Ecology response 4 8 25 re condition 16 Lighting for CS/24/98535 FLYCATCHER ROAD, BOTLEY

HCC Consultation: New two storey school for 125 pupils with Social Emotional and Mental Health (SEMH) needs, with associated external play areas and parking and drop off facilities
Please comment on the information submitted in relation to Condition 16 (Lighting) rec/d 29.7.25

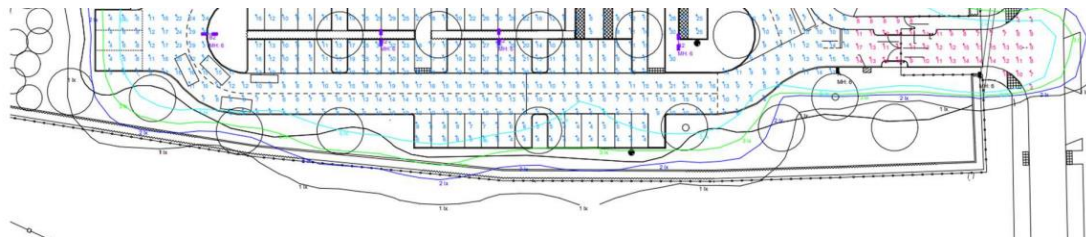
The lighting diagram in section 4 on page 12 shows that many of the trees along the southern edge of the car park would be illuminated by 3 to 5 lux. Is there a way to reduce these light levels to 1 lux or less?
